# Rezoning Transportation Analysis

Petition Number: 2022-160

Date	Description
02-23-23	First Review (PDM)
03-23-23	Second Review (PDM)

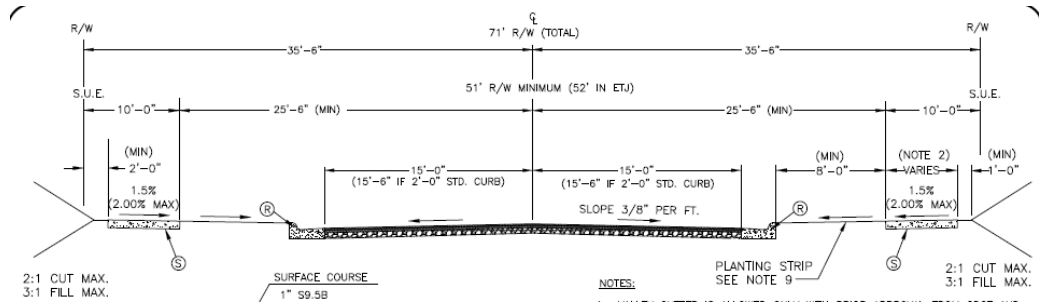
- a. **Mount Holly Road:** Location of curb and gutter to be installed at 33 feet from roadway centerline to accommodate the Charlotte Streets Map roadway typical section of a four plus lane avenue with shared use path.

**UPDATED COMMENT 3.23.2023:** Future back of curb needs to be show at 33ft for entire Mount Holly Road frontage for planning purposes.

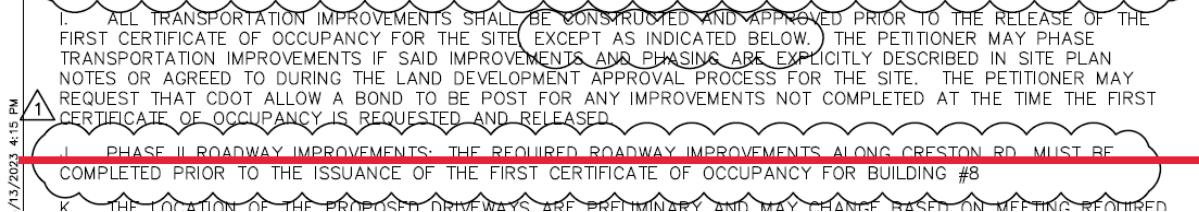
~~6. Per coordination with NCDOT and Subdivision, revise the proposed public street to meet NCDOT standards if the site will not be annexed into the City, or revise road to be a private street with a public access easement. If the site will be annexed into the City and the road is to remain public, the road will need to be realigned to meet CDOT standards and the angled parking will need to be removed.~~

~~7. Add a conditional note specifying "A Right of Way Encroachment Agreement is required for the installation of any non-standard item(s) (irrigation systems, decorative concrete pavement, brick pavers, etc.) within a proposed/existing City-maintained street right of way by a private individual, group, business, or homeowner's/business association. An encroachment agreement must be approved by CDOT prior to construction/installation. Contact CDOT for additional information concerning cost, submittal, and liability insurance coverage requirements."~~
